PLANNING COMMISSION MEETING
Monday, May 28, 2026 – 7:00 p.m.
Farmington City Hall
Council Chambers
23600 Liberty Street
Farmington, MI 48335

**Farmington Planning Commission
Staff Report**

Subject: Vibe Credit Union (Special Land Use Review)
Location: 31806 Grand River Ave (parcel ID: 23-27-403-141)
Zoning: C2 Community Commercial
Plan Date: April 24, 2026
Applicant: Hunter Karam

Subject: Vibe Credit Union (Site Plan Review)
Location: 31806 Grand River Ave (parcel ID: 23-27-403-141)
Zoning: C2 Community Commercial
Plan Date: April 24, 2026
Applicant: Hunter Karam

NOT FOR CONSTRUCTION
PROPOSED SITE & CARPORT INFORMATION
 Project No. 52029 Sheet No. P2
 Date Printed: _____

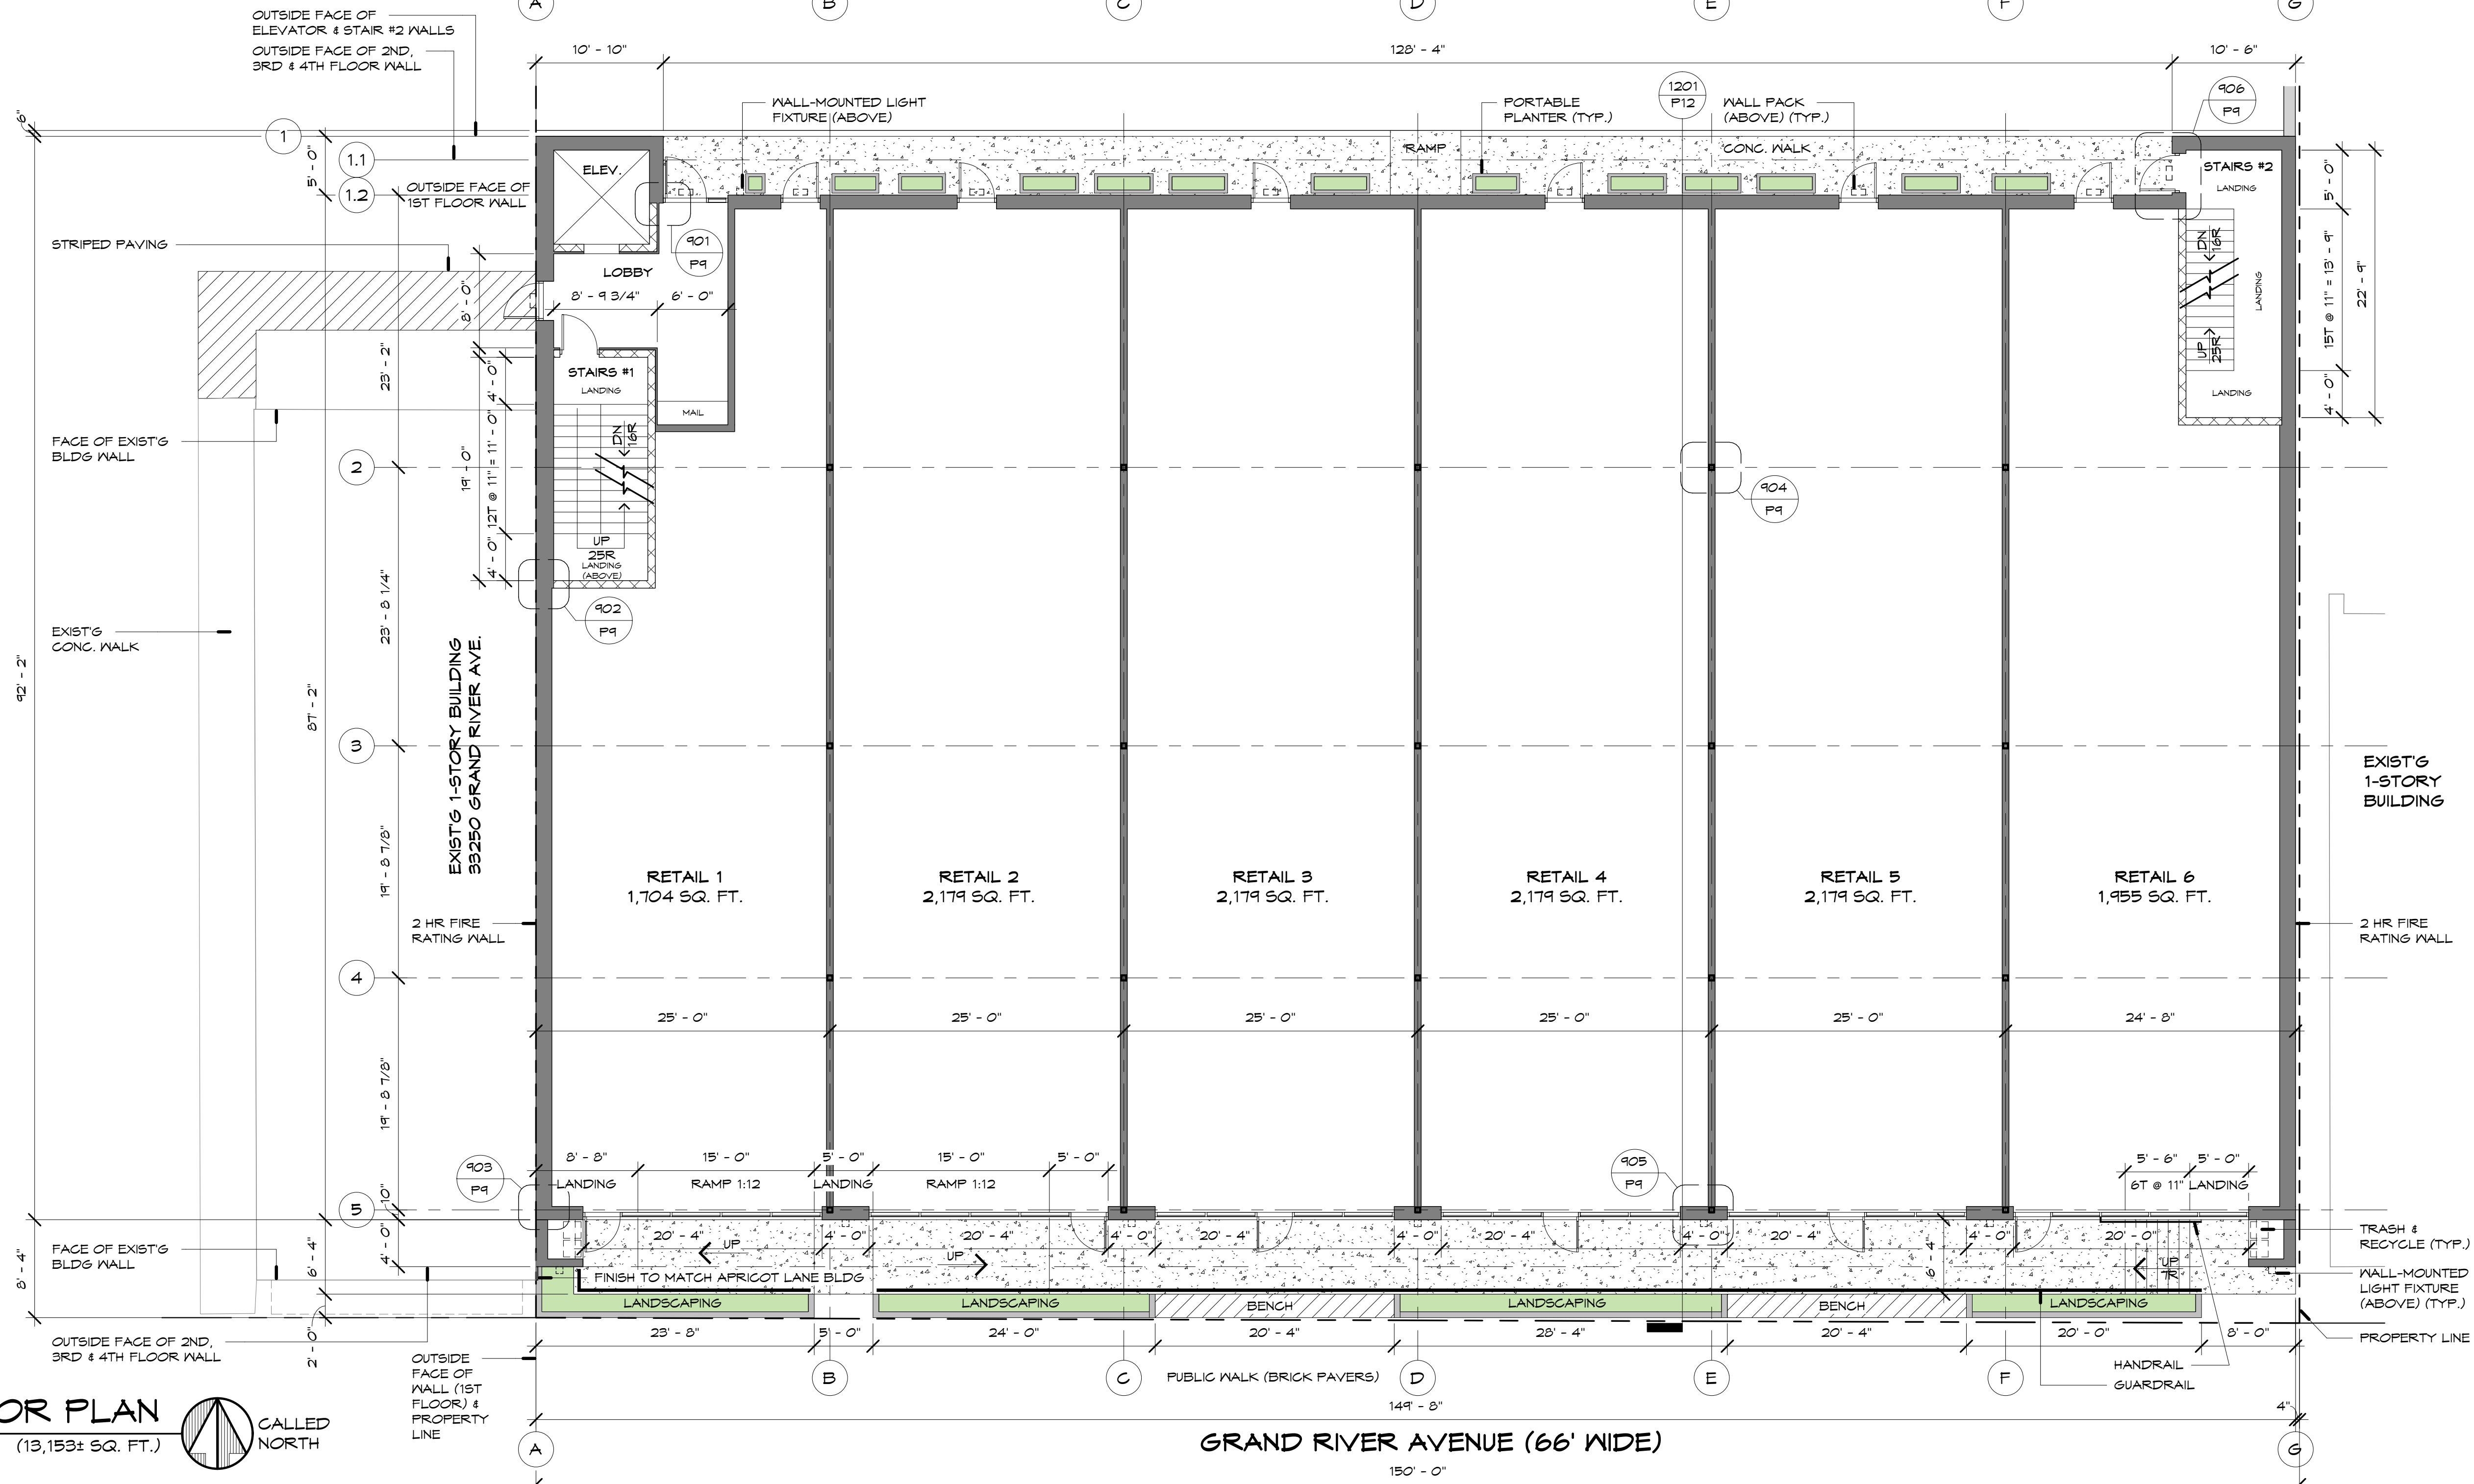
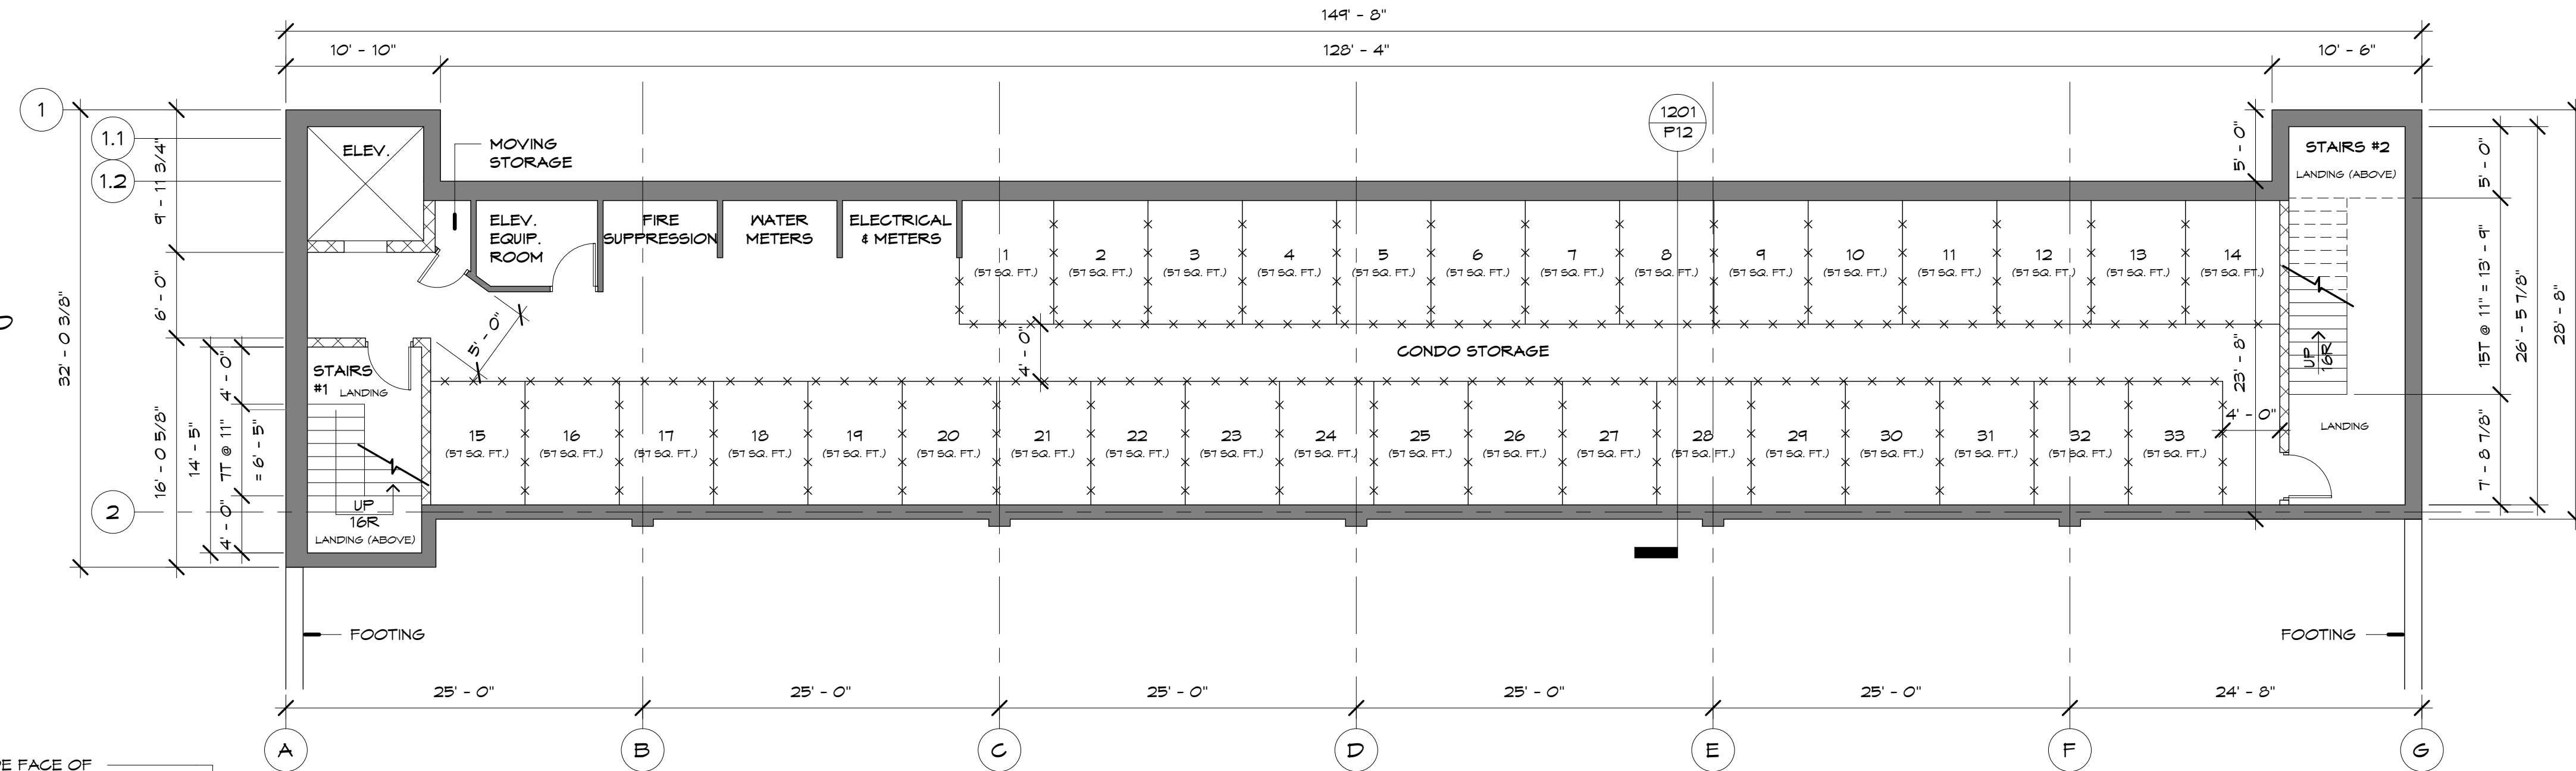
Required	Proposed	Comment
The wall shall be constructed of at least seventy-five (75) percent modular brick or stone.	Façade calculations not provided.	Potentially meets the standard. <u>Based on the elevations presented on Sheet P10, the façade may not meet this requirement. The applicant should submit façade calculations.</u>
Up to twenty-five (25) percent of the remaining wall area may include wood siding, fiber cement siding, exterior insulation finish systems (EFIS), stucco (cementitious finish), precast masonry, metal or molded polyurethane trim.	Façade calculations not provided.	Appears to meet or exceed standard. <u>The applicant should submit façade calculations.</u>
Exterior walls that may be concealed by future building development on adjacent sites may be constructed of lower-cost materials that are consistent with the building façade...	The applicant has proposed brick, metal panel, metal trim, composite material and stone – consistent with the building façade.	Meets standard.
